Hearing Action Points

London Pilots Council (LPC)

Deadline 5 Submission

1. Revised red line boundary

Fig. A. TWF (190428) LPC Amendment Red Line Boundary

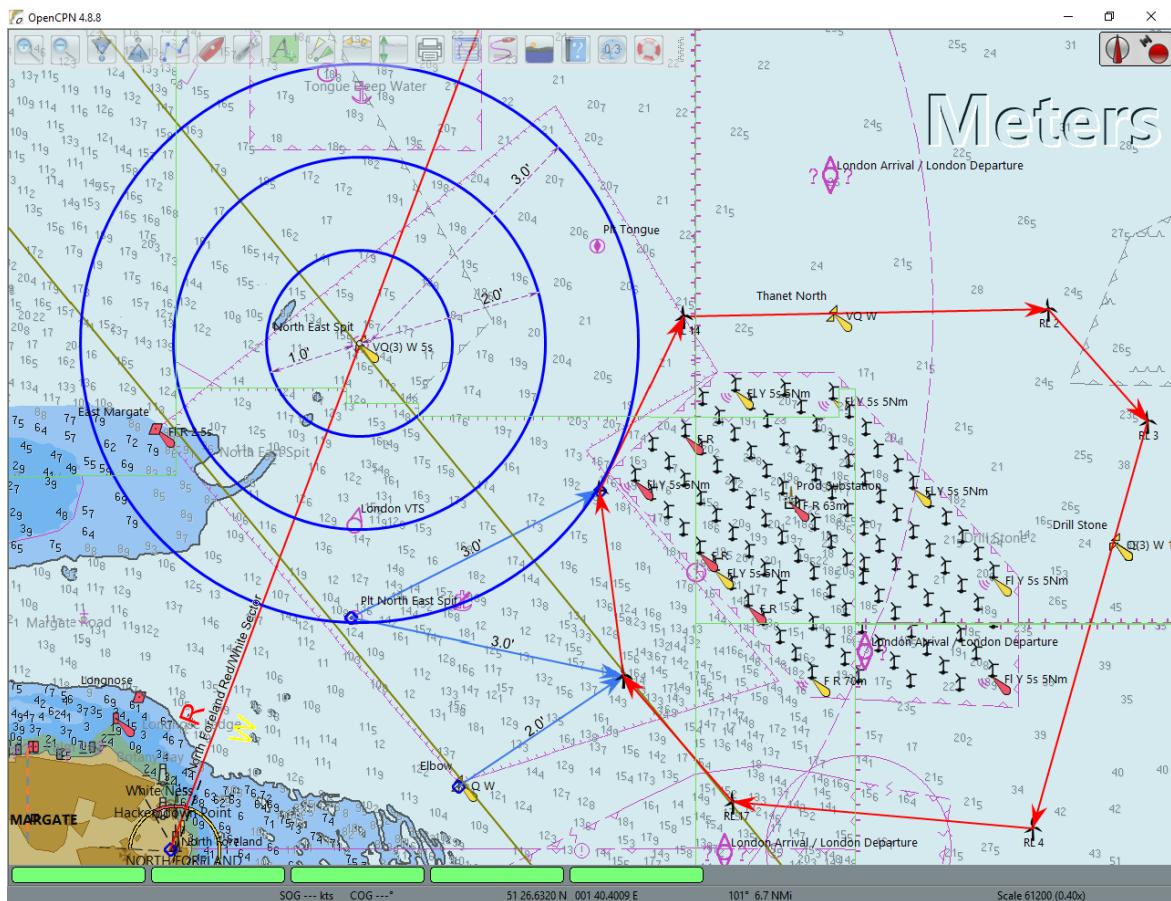
1.1 The LPC were asked to provide clarification of a sketch in their Deadline 4 submissions which showed a preferred red line boundary in order to maximise sea room at the NESP for manoeuvring large vessels, as shown in Fig.1

1.2 Coordinates

51 28.2531 N 001 35.4912 E

51 28.3316 N 001 41.7848 E

51 27.1225 N 001 43.5079 E

51 22 7387 N 001 41 5144 E

51 22.7887 N 001 41.5144 E
51 23.0220 N 001 36.3389 E

51 23.0220 N 001 38.3389 E

51 24.3493 N 001 34.4203 E

Fig. B

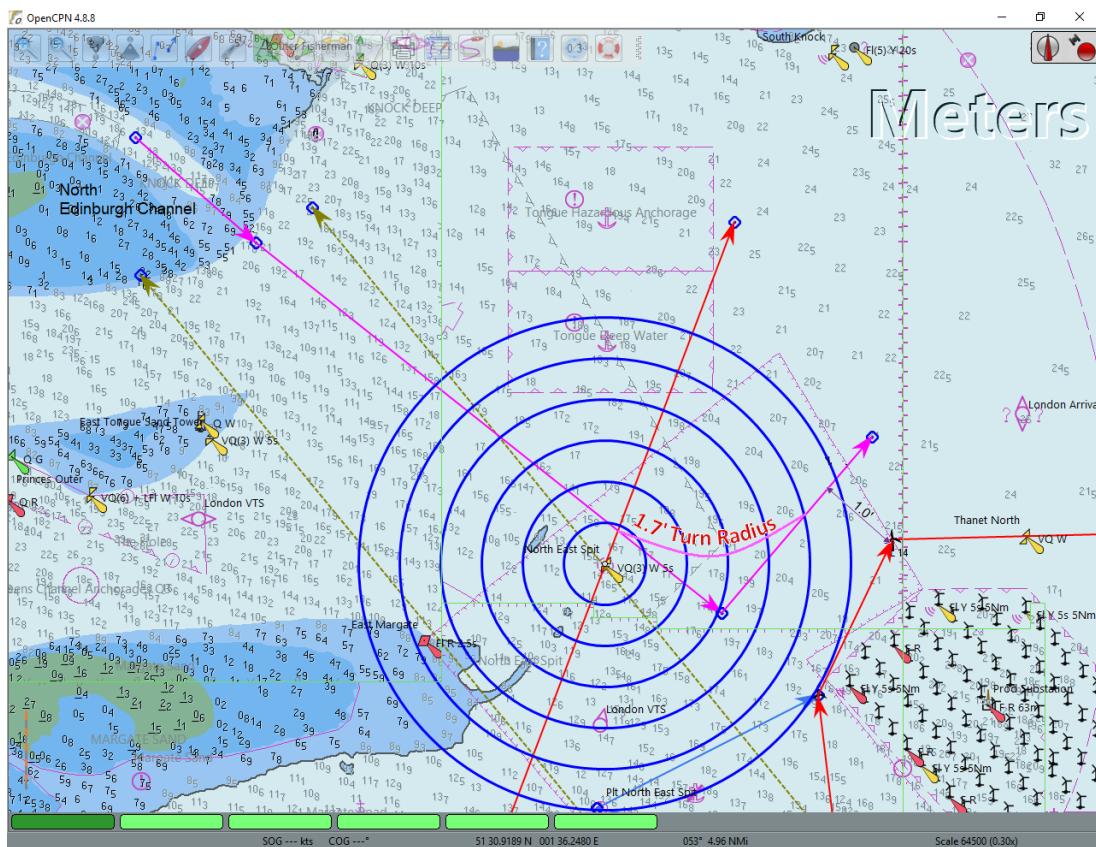
2.6 Combining all of these factors then it is not in the best practice of seamanship or vessel safety to initiate and complete a manoeuvre requiring a large change of heading of a ULCS for a Pilot in less than 2 miles sea room. The time and distance factor for margin of error is very small and as such the LPC require a minimum 1 mile SEZ in addition to the two miles sea room as shown in Fig.B.

Large and ULCS vessels departing the North Edinburgh Channel for Pilot disembarkation at a position ESE x 0.5 miles from the NESP Racon Buoy. Headings available for Pilot transfer from SE, Easterly and NE at 6 mins slow speed requires approximate turn radius between 1.0 mile and 1.7 miles for ULCS vessels. Rate of turn between 5 and 10 degrees. (ROT = V/Radius) (Info from vessel bridge manoeuvring data IMO Res.A601(15)) Change of heading shown is 90 degrees, from 130 degrees inward to Pilot disembarkation turning to 040 degrees outward to the VTS reporting point.

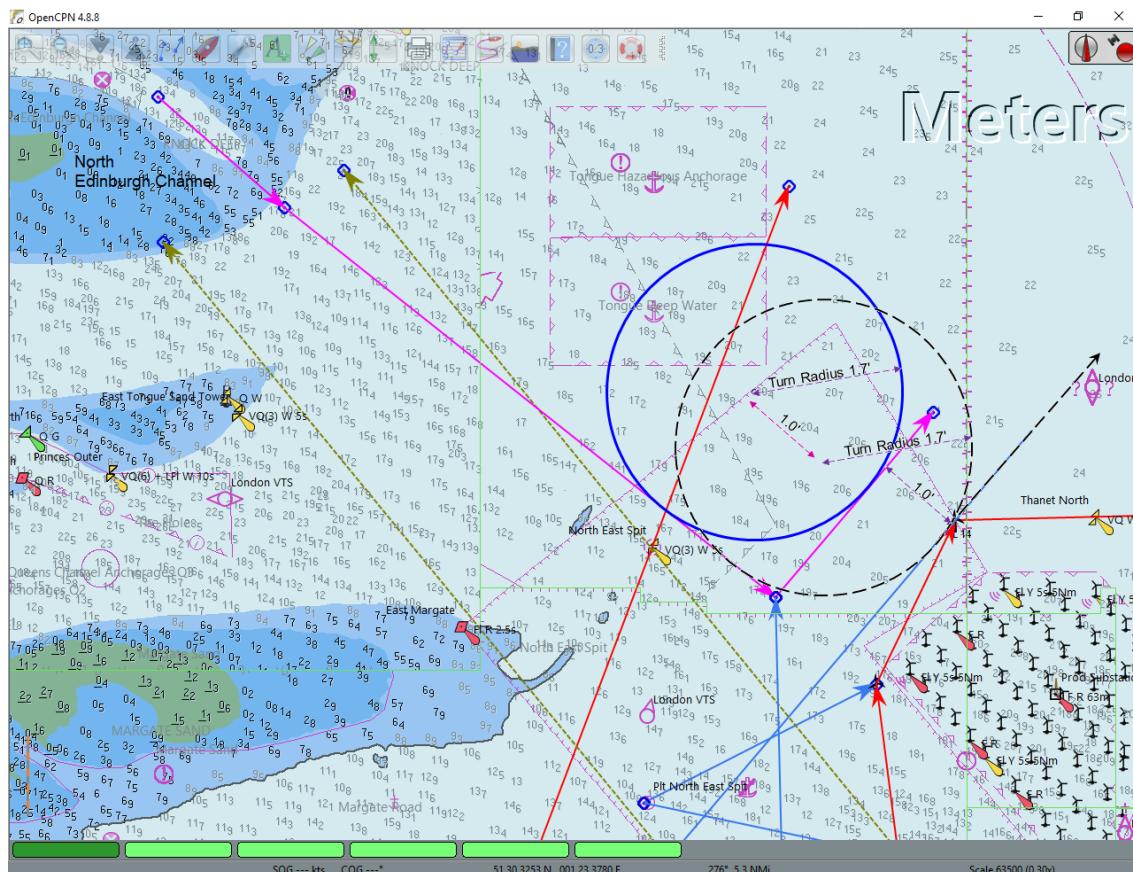
2.8 Fig.C shows how critical speed and position is for boarding and landing Pilots in this area and why a 1 mile SEZ is critical to the safe operation of vessels. It can be seen that using the same turn radius and the vessel requiring approximately 6 minutes to board a Pilot then the vessel has only to overrun its turn position abeam of the NESP Racon Buoy by 1 mile or at Dead Slow Ahead on a Cap San of 7.5 knots, 8 minutes, then the vessel would be in close proximity to the Windfarm.

3.3 Fig.C clearly shows that by overrunning the turn position by 1.0mile or 8 minutes in time or losing the rate of turn and increasing the turn radius then the vessel will be in close proximity to the Windfarm within a very short space of time

Fig.C gives a clear picture of the requirement for a 1 mile SEZ in addition to the required 2 miles of sea room.

5.5. Fig.1 London Array Windfarm

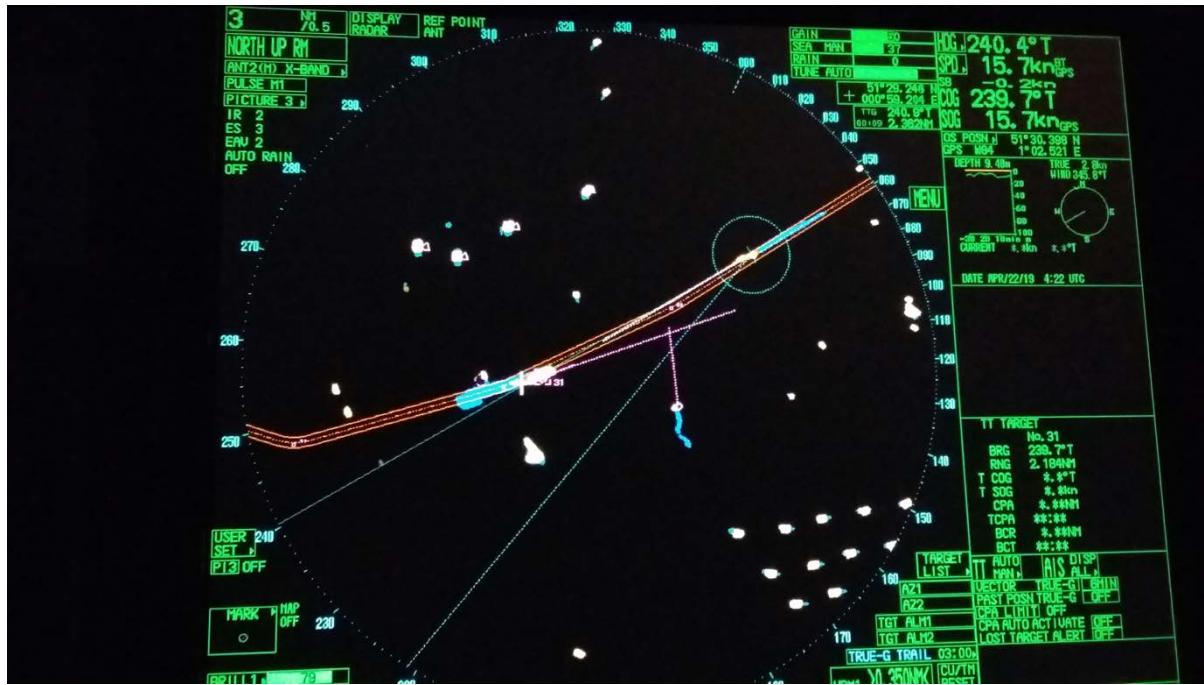
Radar range 6 miles offset. Vector length 6 minutes. Medium pulse.

Target Vessel plotted at 9 miles, 19 minutes on closing speeds to determine if risk of collision exists.

This snap shot shows Target vessel, speed 16.8 knots on reciprocal course at 2.5 miles distant. Time to closest possible approach 4 minutes. Own vessel takes avoiding action by altering course to Starboard in accordance with the COLREGS.

Target vessel would not have even appeared on Captain Moore's screen for another 1 min 15 seconds !!

5.6 Note in Fig.1 The London Array Windfarm is at 1.0 mile. A small alteration of course of only 10 degrees for collision avoidance brings the Pilots vessel into conflict with the Windfarm in less than 12 minutes. This again demonstrates very clearly why the LPC require a 1.0 mile exclusion zone in addition to the 2 miles sea room to the North and West of the proposed Windfarm extension

Fig.3 Kelvin Hughes Radar Pulse Settings

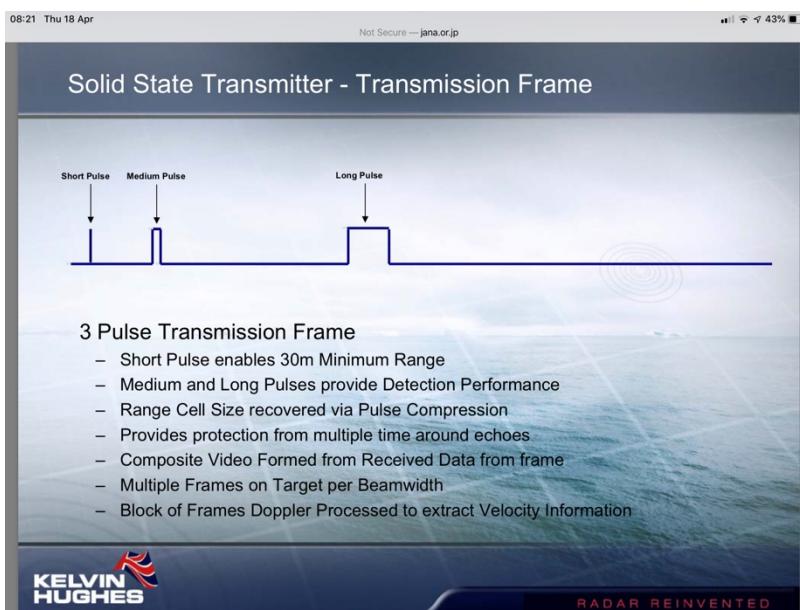
6.3 Without going into the science of pulse length, short pulse (SP) energy gives clear sharp definition of fixed targets at very close range typically buoys, berths, anchorages and channel edges. Medium pulse (MP) energy gives adequate definition of targets for plotting, such as target vessels, racon buoys and use in passage monitoring. Long Pulse (LP) energy is used typically in making landfall at long range. See Fig.3

6.4 On most marine radars the pulse settings are automatically selected as the range scale is changed. The Kelvin Hughes operation manual shows Short Pulse (SP) for ranges 0.25, 0.5, 0.75 and some 1.5 mile ranges. Medium Pulse (MP) is an auto setting for ranges 3 and 6 miles and finally Long Pulse settings (LP) for 12 and 24 and radars with a 48 mile ranges.
